EQ754-200150/A – Rideau Canal – Ottawa Walls Repairs – Clegg Street Area:
Addendum 1 Text

August 22, 2019

Figure 1-

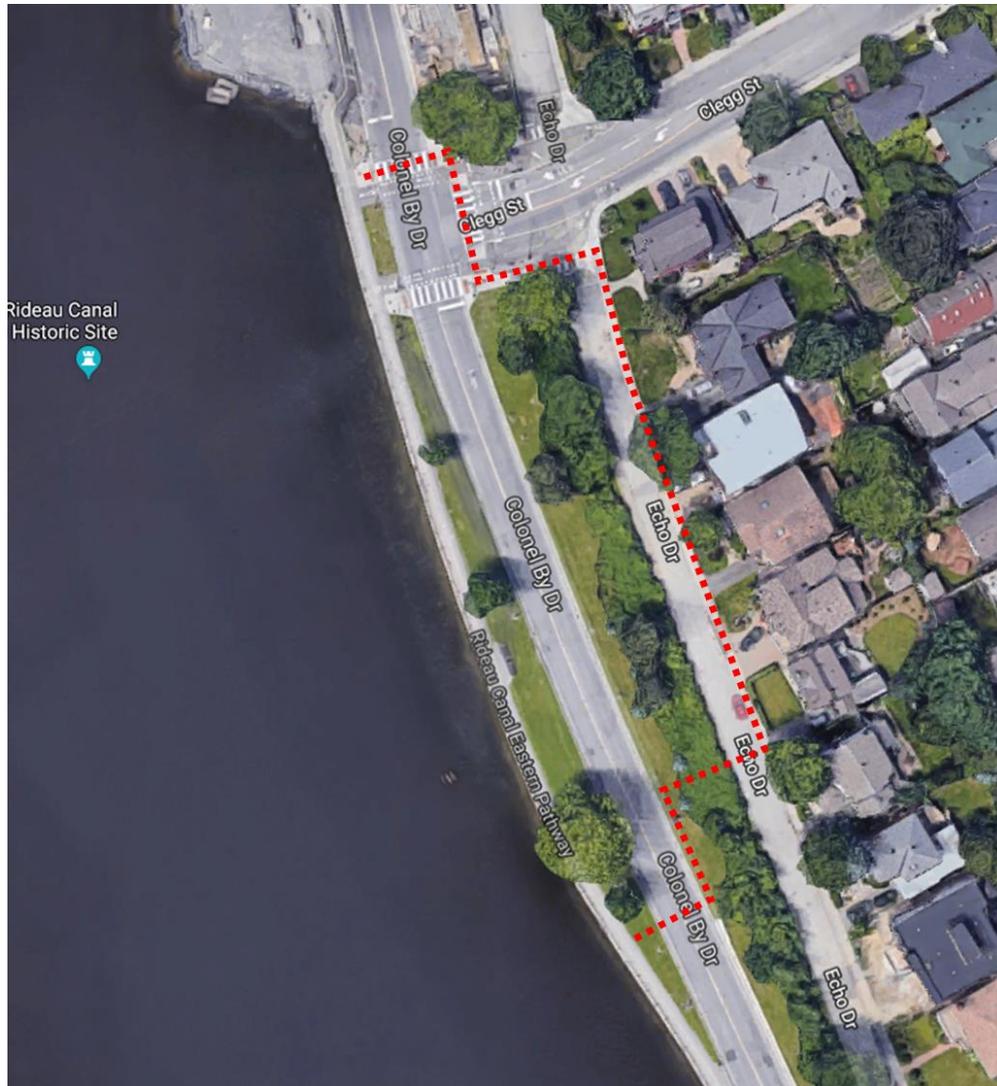
Contractor shall develop and submit the final plan for pedestrian and cyclist detour using the detour path indicated in Figure 1; which replaces the proposed pedestrian detour plan shown on cover sheet of tender drawings. The final detour plan shall be design accordance to the City of Ottawa’s applicable regulations and standards.

Notes for pedestrian traffic detour:

1. Clear shrub on median between Echo Dr. and Colonel By Dr. Clearing of shrub to max width of 3m. Reinstall all ground to original material/shape and replace removed shrubs with similar plants.
2. Ensure that the detour pathway through median remains outside the drip line of trees, and provide tree protection as required.
3. Pathway through median between Echo Dr. and Colonel By Dr. and on the median between Colonel By Dr. and the canal pathway shall be paved in accordance to the specifications.
4. Concrete curb on either side of Colonel By Dr. will need to be lowered at the pathway to facilitate smooth transition to and off the road. The removed curbs shall be reconstructed after removal of pathway.
5. Maximum pathway grade to be 1:12 (8%) and shall be barrier free design.

6. Pedestrian crossing on Colonel By Dr. to have a pedestrian crossing signals which will need to be coordinated/interfaced with the traffic signal at Clegg St. to minimize traffic impact, meeting all pedestrian crossing of the City of Ottawa regulations and standards.
